California Department of Fish and Game
North Central Coast Study Region
Feasibility Evaluation of Draft MPA Proposals
February 11, 2008

Point Arena SMCA and SMR: A floating corner is created at the south- western corner of the SMR. Offshore corners should be located at whole minute lines of latitude and longitude (see: general suggestions for improving the feasibility of the draft proposals; bullet #2).

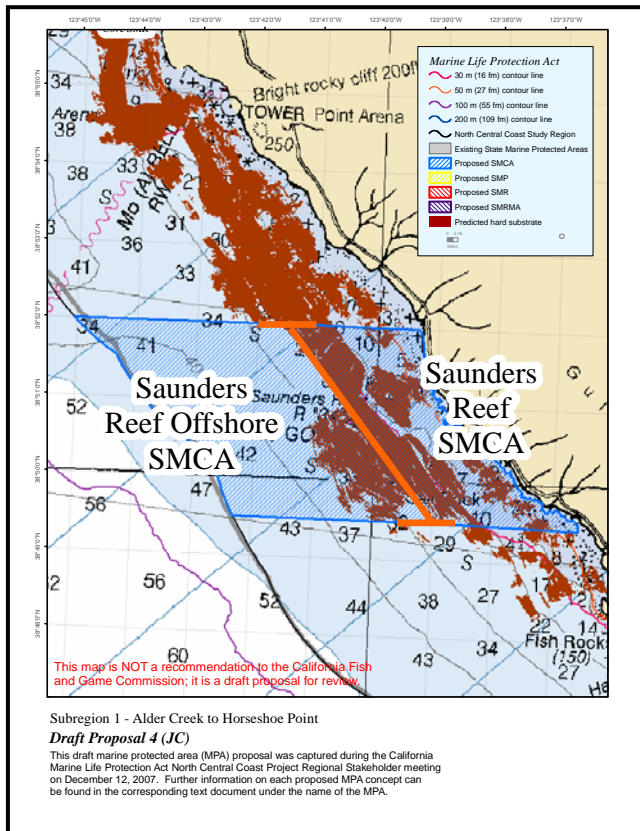
- Floating corners are difficult to enforce.

Del Mar SMR: Boundaries do not follow a due north/south east/west orientation, are irregularly shaped, and are not at easily recognizable landmarks or at readily determined lines of latitude and longitude.

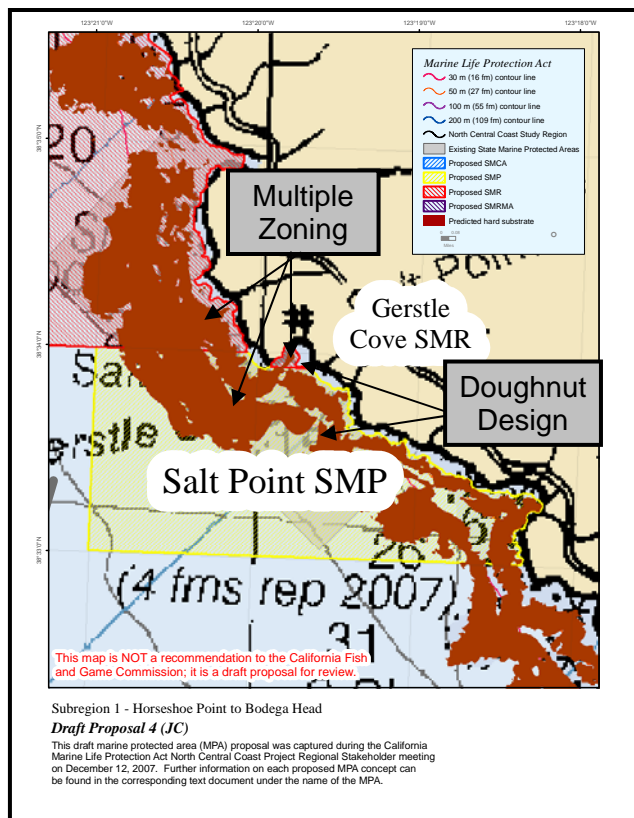
- These boundaries are difficult to enforce and prosecute in a court of law.

Gerstle Cove SMR and Salt Point SMP:
 Doughnut design with Gerstle Cove SMR inside of Salt Point SMP. Multiple zoning was created with Black Point SMR, Gerstle Cove SMR and Salt Point SMP.

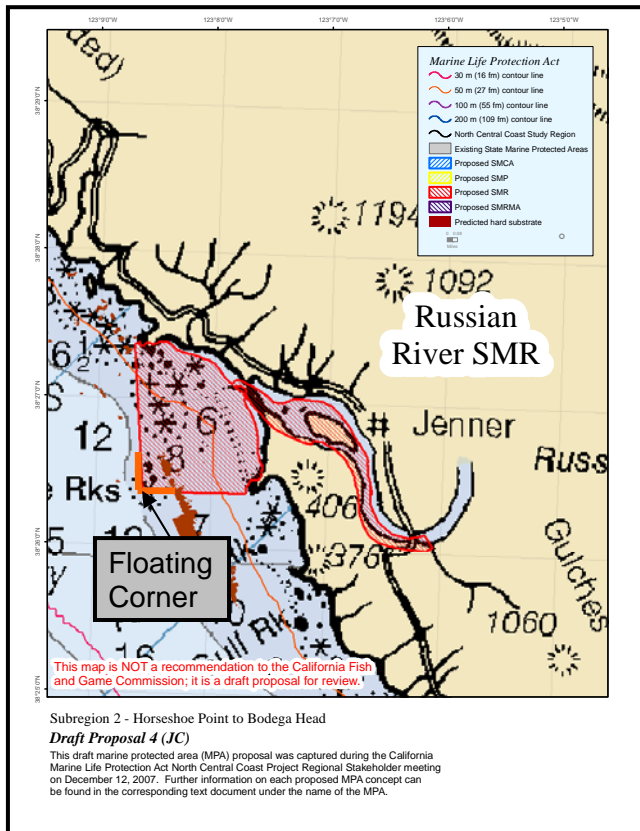
- Enforceability and public understanding would be enhanced by simplifying this cluster.

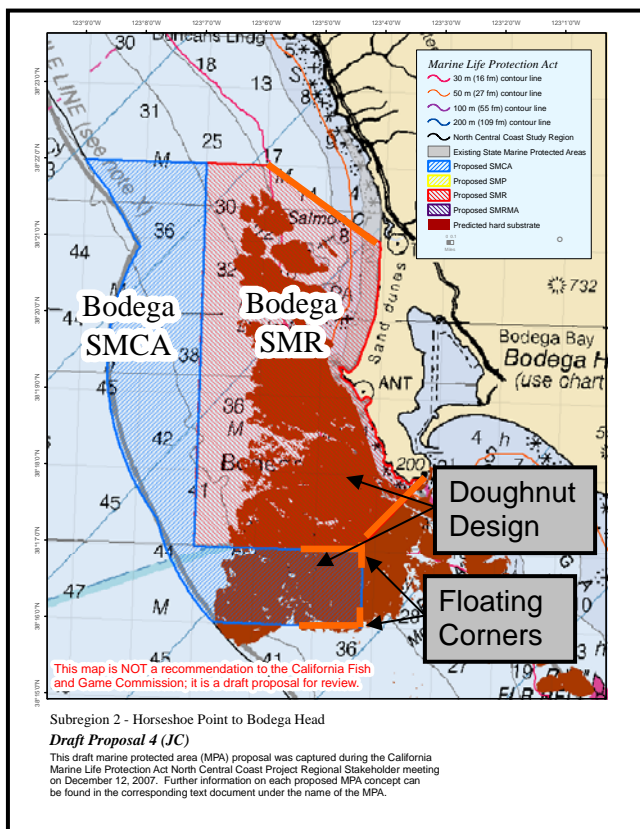
Russian River SMR: A floating corner was created in the south-western corner of the SMR (see External Proposal A (round 2) for a similar sized/ positioned MPA using coordinates that meet feasibility guidelines). Offshore corners should be located at whole minute lines of latitude and longitude (see: general suggestions for improving the feasibility of the draft proposals; bullet #2).

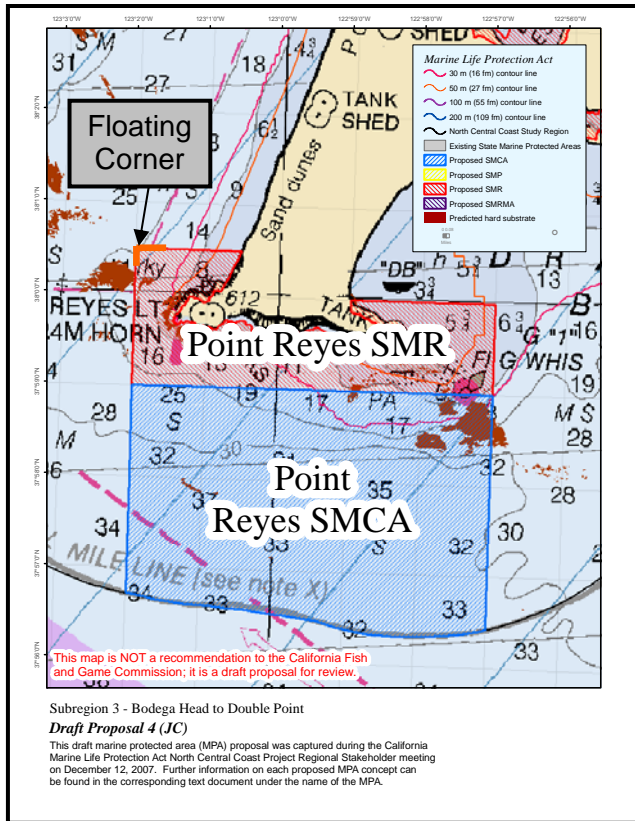
Bodega Head SMR and SMCA: The northern boundary of the SMR is a diagonal line that does not follow the angle of the coastline. The landmark utilized in the north-eastern corner of the SMR ("the tanks") is not considered a permanent landmark. Doughnut design with Bodega Head SMR surrounded on two sides by Bodega Head SMCA. Floating corners were created in the south eastern corner of Bodega Head SMR and the south-eastern corner of Bodega Head SMCA. Offshore corners should be located at whole minute lines of latitude and longitude (see: general suggestions for improving the feasibility of the draft proposals; bullet #2).

- The diagonal northern boundary of the SMR would be difficult to enforce and prosecute in a court of law.

Pt. Reyes SMR and SMCA: A floating corner was created in the north-western corner of Point Reyes SMR. Offshore corners should be located at whole minute lines of latitude and longitude (see: general suggestions for improving the feasibility of the draft proposals; bullet #2).

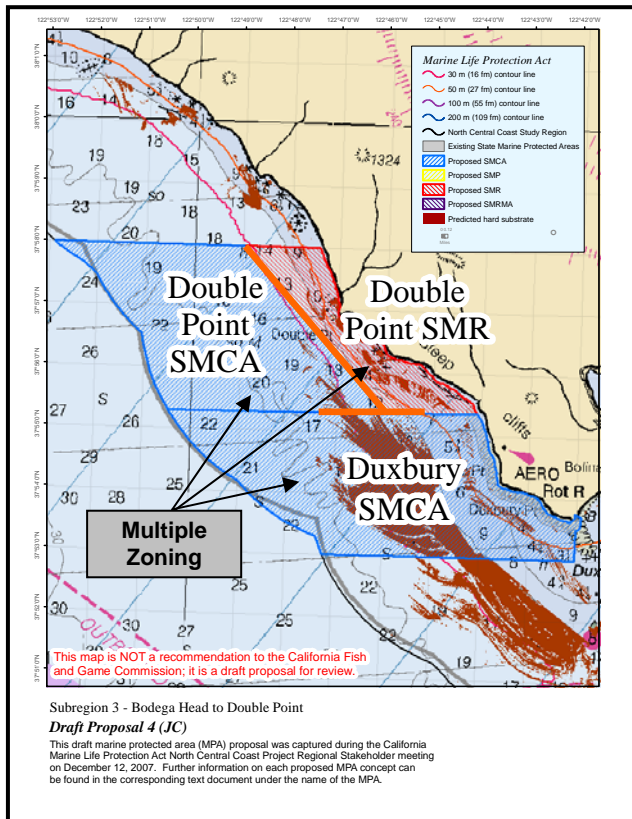
- Floating corners are difficult to enforce.
- This area is remote and a long response time is expected.

Double Point SMR/ SMCA; Duxbury Reef

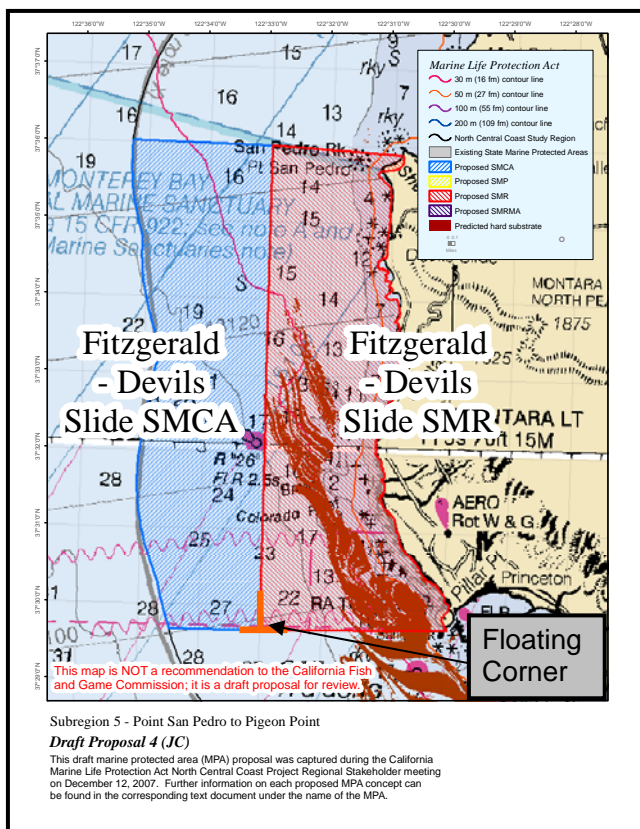
SMCA: The western boundary of Double Point SMR is an unanchored diagonal line. Diagonal lines may be feasible when they follow the angle of the coastline and are anchored at whole minute points of latitude and longitude. Multiple zoning was created with Double Point SMCA, Double Point SMR and Duxbury SMCA. Enforceability and public understanding would be enhanced by simplifying this cluster.

- Enforceability and public understanding would be enhanced by simplifying this cluster.
- This area is remote and a long response time is expected.
